# PERFORMANCE BULLETIN

August 20, 2001

## New Auxiliary Brine Cam Switch & Motor Bracket

Figure 1

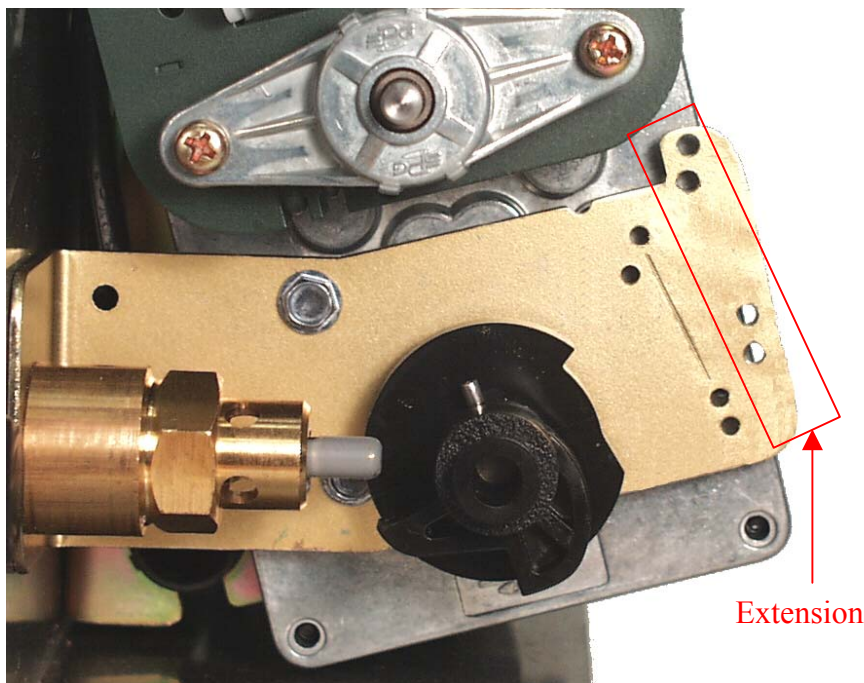
Due to the change of our drive motors, the auxiliary brine cam switch and motor bracket will be changed to improve the wiring of the auxiliary switch. Effective mid September 2001, an **extension** (Fig. 1) will be added to the motor bracket to accommodate the new **auxiliary switch** (Fig.2) on all 1500, 2510, 2750, 2850, and 2900 control valves.

The new bracket will retrofit existing control valves. The new bracket part number will be **11826-02** and the auxiliary switch is **10896**. On the backside is a picture showing the auxiliary switch positions and locations for both the old and new style switches.

## Auxiliary Switch Positions and Locations

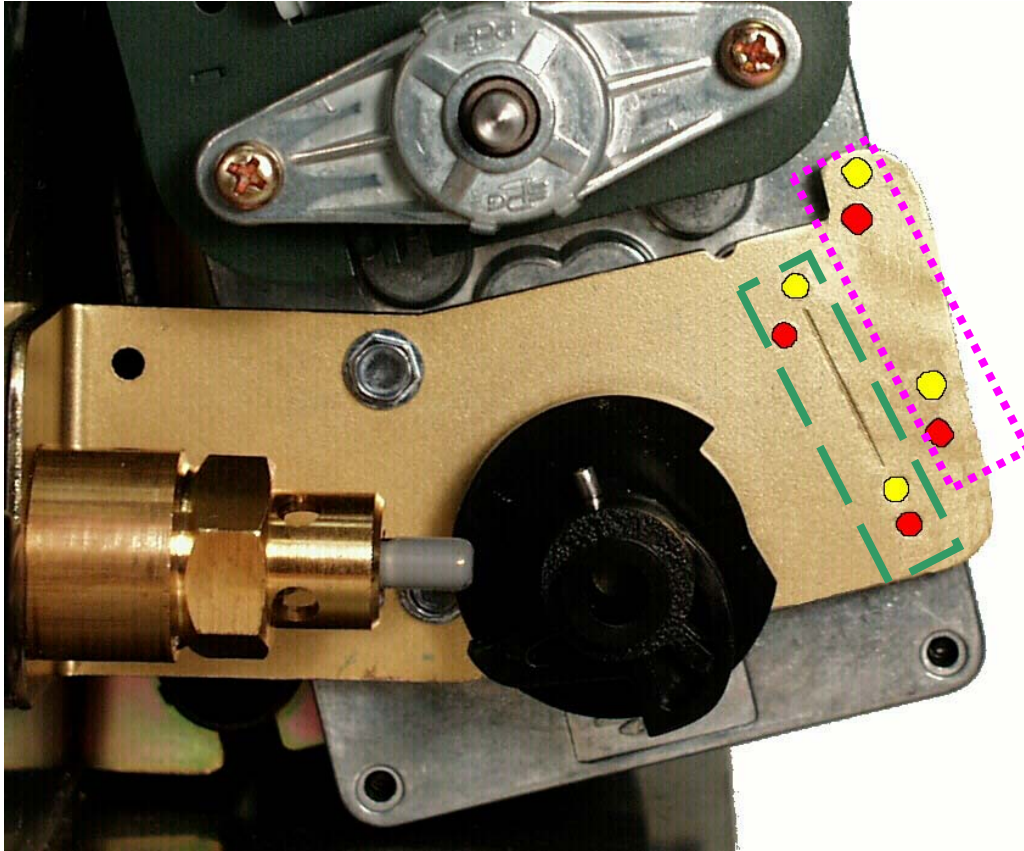
### Old Style Auxiliary Switch

Auxiliary Switch:	10218
Auxiliary Switch Kit:	60320-07
Switch Location:	 Turn on the start of regeneration Shut off after Brine Tank Refill
	 Turn on the start of regeneration Shut off after Rapid Rinse

### New Style Auxiliary Switch

Auxiliary Switch:	10896
Auxiliary Switch Kit:	60320-12
Switch Location:	 Turn on the start of regeneration Shut off after Brine Tank Refill
	 Turn on the start of regeneration Shut off after Rapid Rinse
